Date: 14 November 2025
Ref: A006530099

**RE: RESPONSE TO FURTHER ADVICE
409 PRIESTDALE RD ROCHEDALE QLD 4123**

Figure 2 – Earthworks Offset

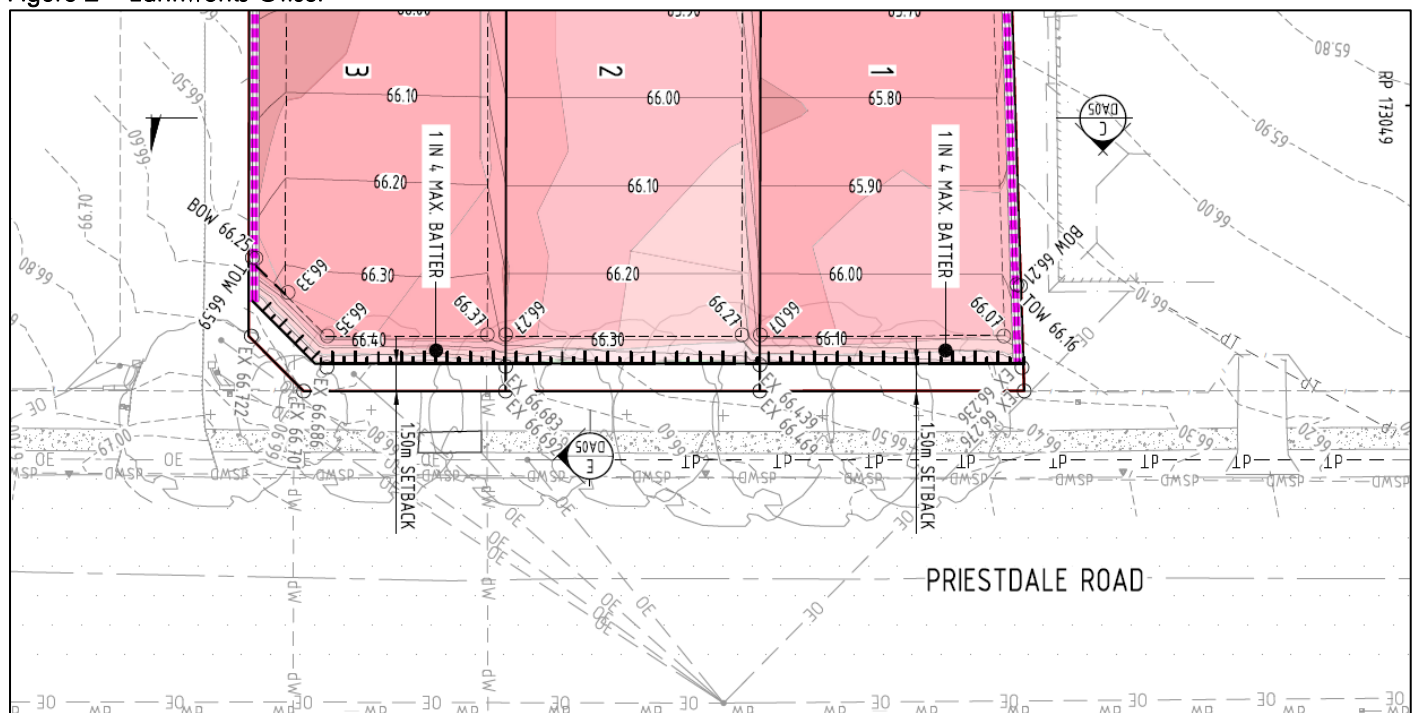
3) An Arboricultural Impact Assessment has been reviewed and it has been identified that the proposal will impact the significant root zones (SRZ) of the street trees due to the proposed cut and location of the retaining wall on the northern boundary.

a) Provide amended plans reducing the amount of works intruding into the SRZ and tree protection zones (TPZ) of the street trees by relocating the retaining walls within proposed lots 1 – 3.

b) Provide an amended Arboricultural Impact Assessment to demonstrate the proposed works and areas of cut within the TPZ has no negative impacts on the long-term health of the street trees.

Please refer to the amended earthworks plan, which relocates the cut batters within Lots 1–3 1.5m south of the front boundary in accordance with PPI Arboriculture’s advice. This removes earthworks from the SRZ of the existing street trees. A stabilised batter is proposed instead of a retaining wall, allowing this area to be landscaped and integrated into the private open space garden areas of each future Dwelling House.

Tree Science is currently preparing an updated Arboricultural Impact Assessment, however is operating under a high workload and therefore, a final copy may not be available for several weeks. As the amended earthworks design implements PPI Arboriculture’s preferred solution, we request that Council apply an amended in red to the current arborist report to reference the new earthworks design.
